SECTION 3

DRIVE-CONTROL

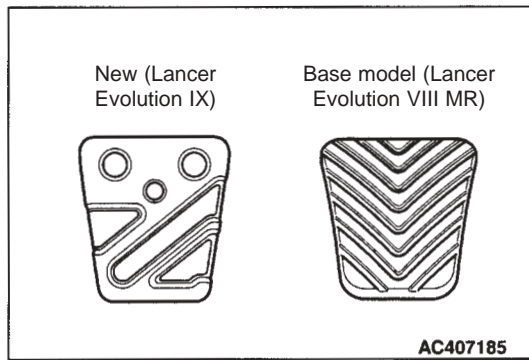
- Newly designed aluminium wheels have been fitted. These are lighter, but retain a high level of stiffness. (GT, GSR : standard, RS : option)
- In view of the diverse range of needs in the market, and to save on weight, there is no spare tyre. Instead, we provide an emergency puncture repair kit. A spare tyre is offered as an option.
